Rezoning Transportation Analysis

Petition Number: 2018-165

General Location Identifier: 16719305

Date	Description
01-18-19	First Review

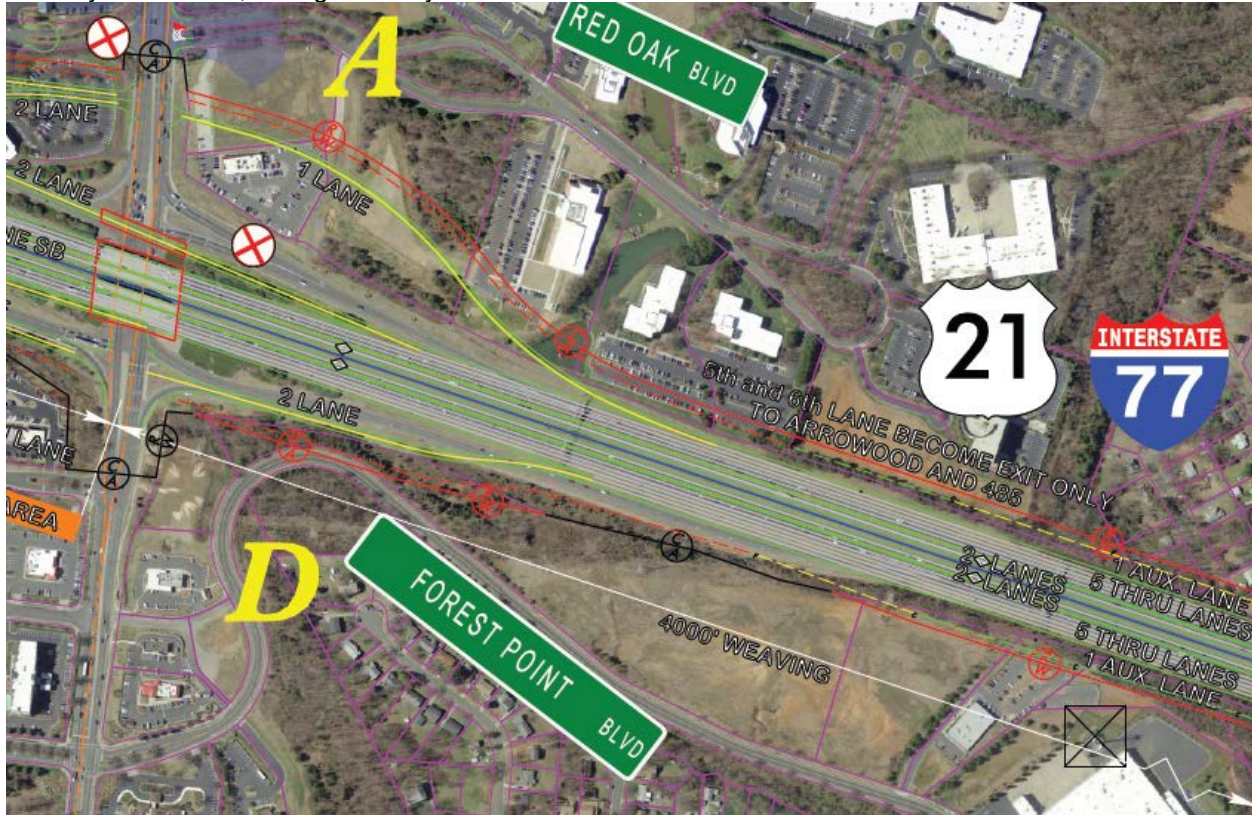
- ~~1. Traffic Study A Traffic Impact Study/Transportation Technical Memorandum is not necessary for the complete review of this petition.~~
2. The petitioner shall revise the site plan and conditional note to commit to pedestrian improvements for the intersection of Forest Point Boulevard and West Arrowood Road.
3. I-77 is identified to be widened in the future. A preliminary study was completed showing the possible lane configuration. The petitioner should revise the site plan and conditional notes to show the future

right-of-way as this may affect the site layout. The petitioner should commit to dedicating the right-of-way. In addition, the right-of-way should be labeled and dimensioned from the road centerline.

4. The petitioner should revise the site plan to add a note specifying all transportation improvements will be approved and constructed before the site's first building certificate of occupancy is issued. The petitioner may phase transportation improvements if said improvements and phasing are explicitly described in site plan notes.
